Request For Information

St Mary's Harbour

UA006818

Subject: Quay widening

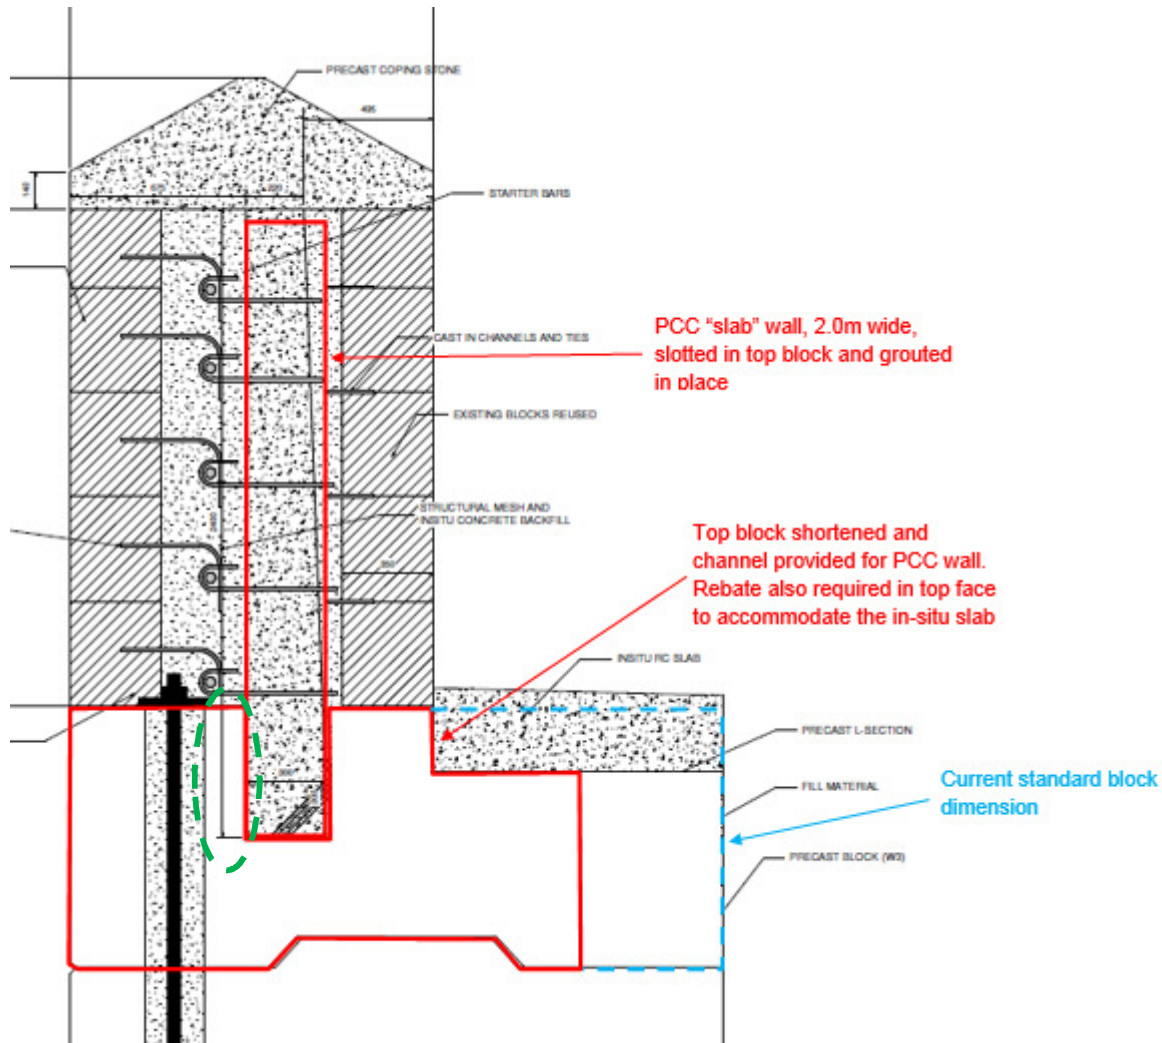
We would like to propose a new block shape to facilitate the construction of the wave wall. The block would be as outlined below, it's length matching that of block W2. In order to achieve this shape the cast face would need to be changed to the top or the side in order to ensure concrete fills the area circled.

Can you confirm that this is possible before we progress with the detailed design of the block?
